Item 12.2.1

ORDINARY COUNCIL MEETING

SHIRE OF DARDANUP PROPOSED AMENDMENT TO LOCAL DEVELOPMENT PLAN, LOT 2 BANKSIA ROAD, CROOKED BROOK

RE: Revised draft Local Development Plan (plan: 21/014/002F ; dated: 04/06/2021) — Lot 2 Banksia Road, Crooked Brook

CONTEXT PLAN

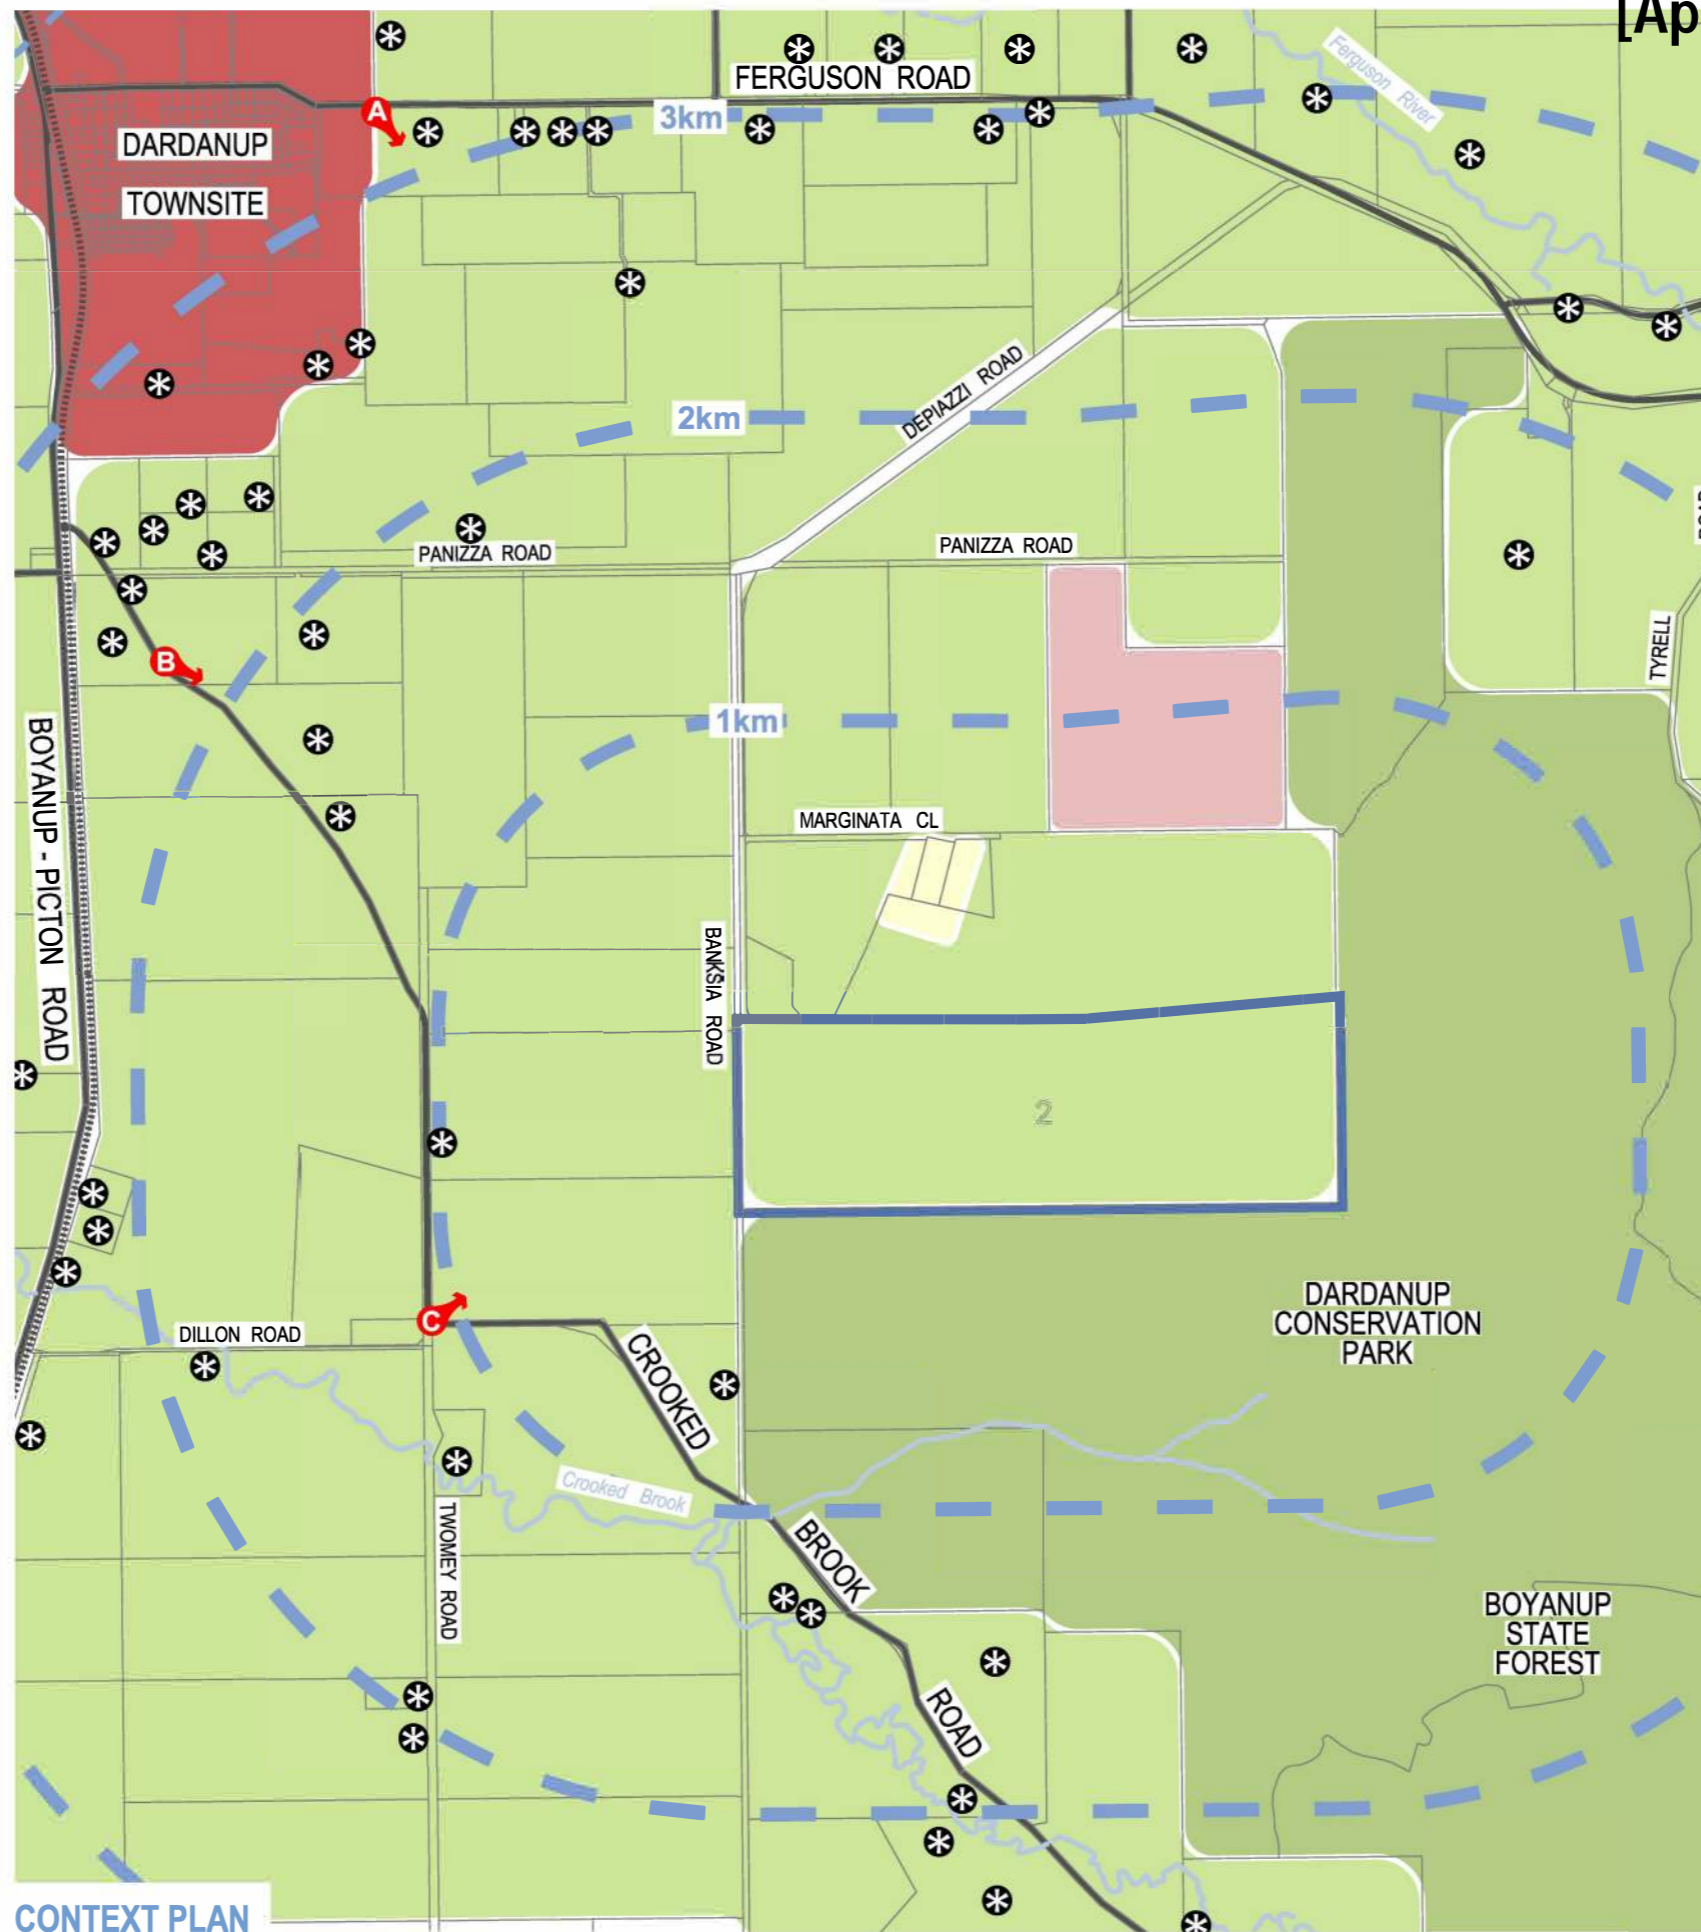
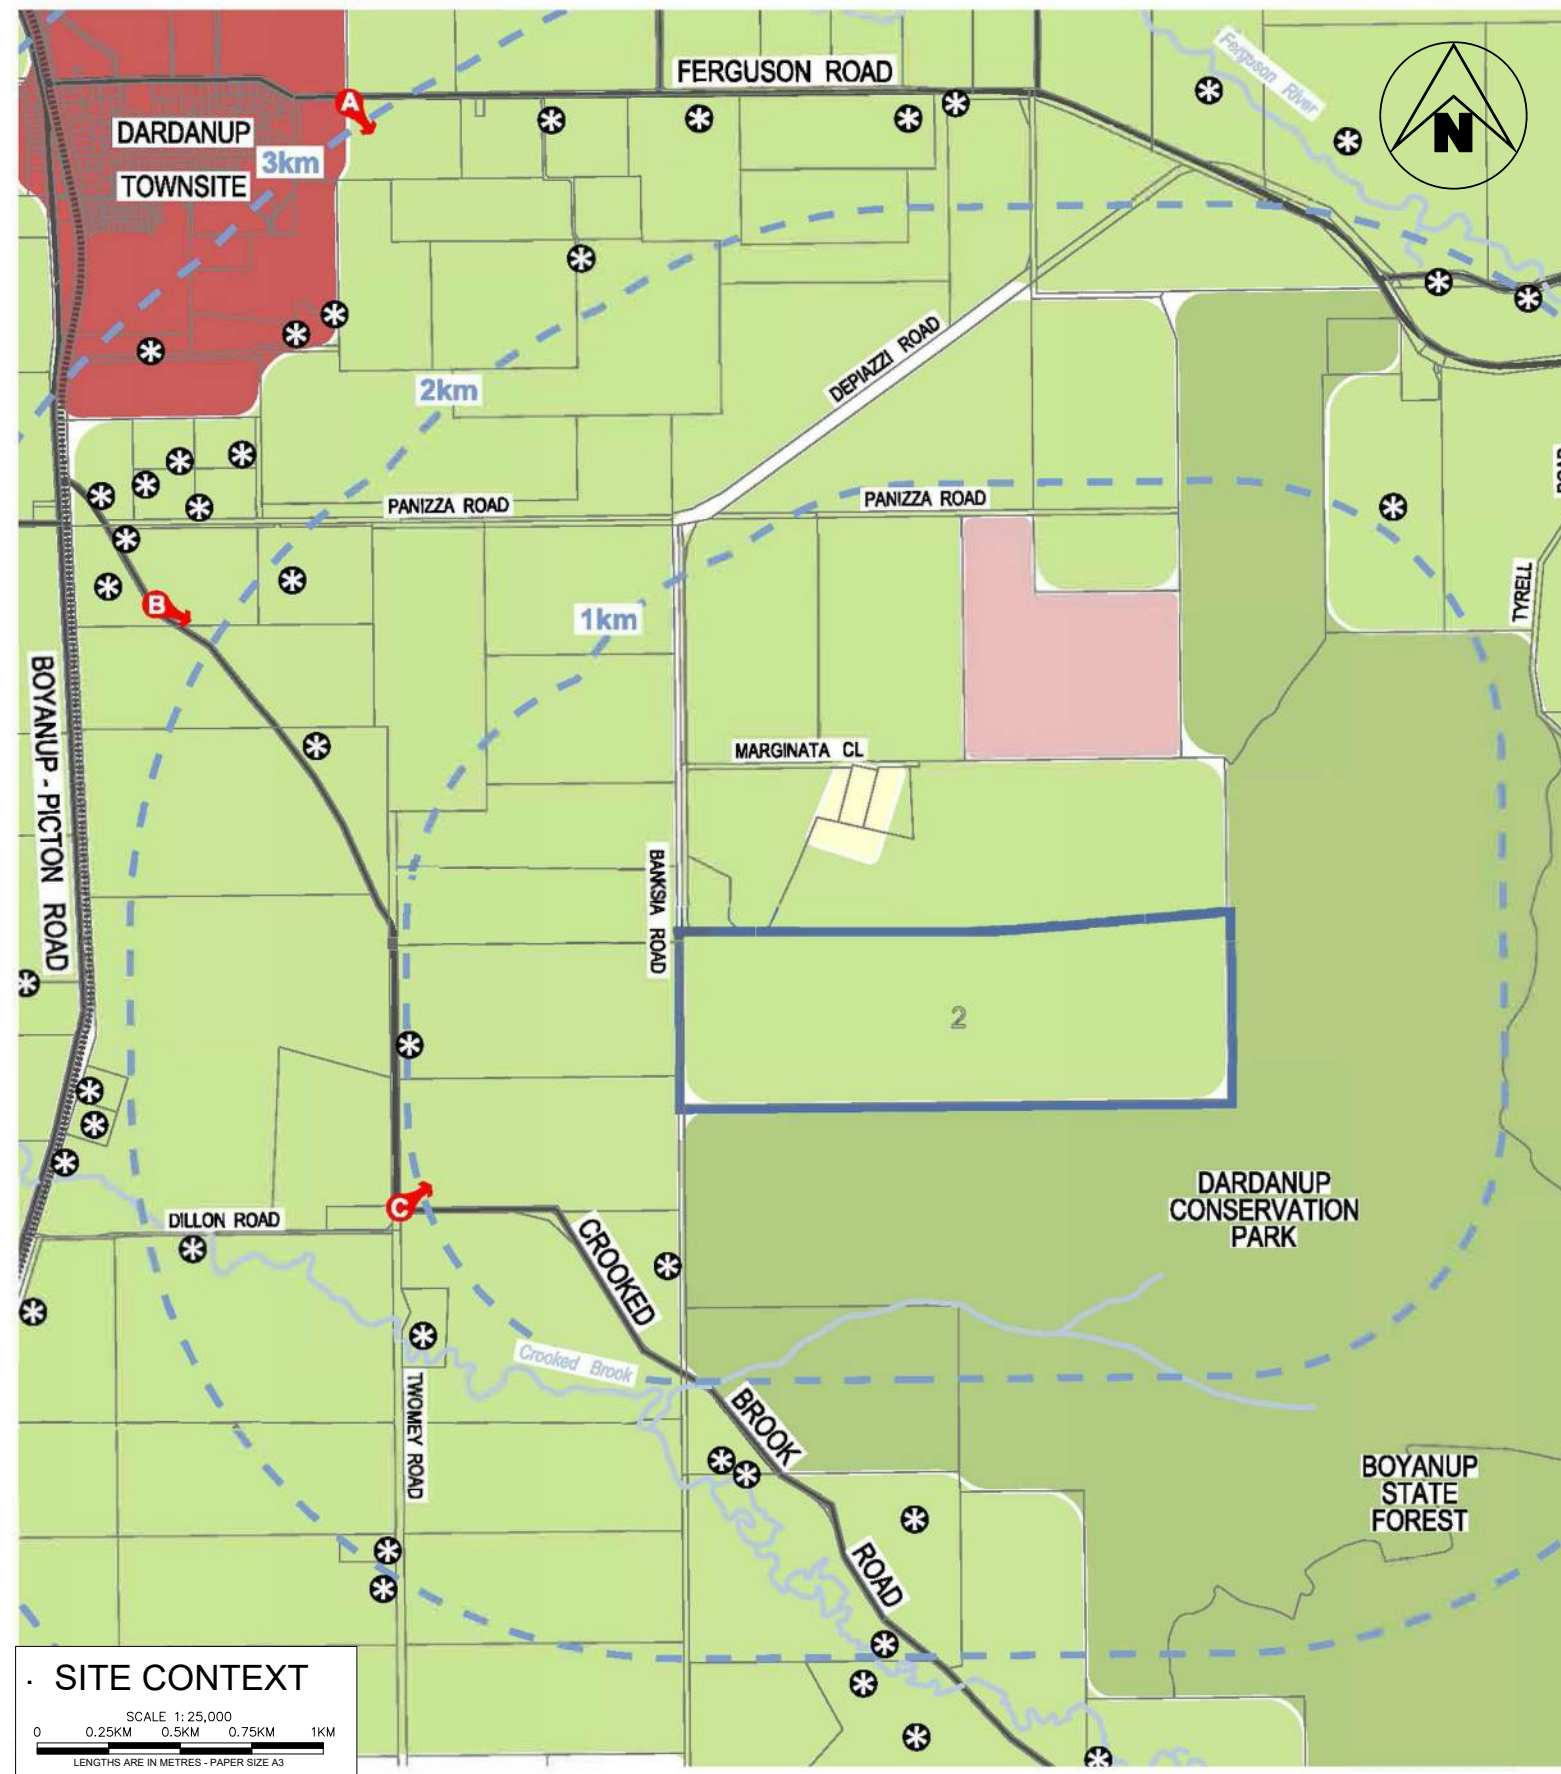
In the site context plan Cleanaway have erred in drawing the 1km, 2km and 3km contours on the map. It would appear that their map does not reflect the LDP subject site, but includes the adjoining block on Marginata Close. Dardanup Council's LDP correctly specifies Lot 2, Banksia Rd.
